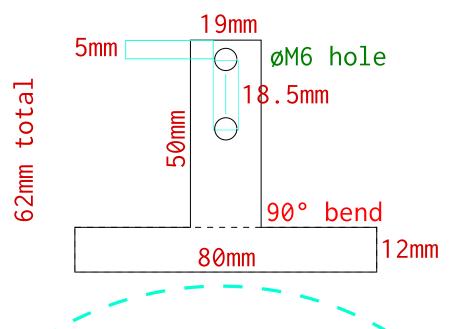
Mods(marked in green):

1. The holes have to be M6 clearance holes.

Wrap this flat surface around a cylinder of ø175mm to curve it
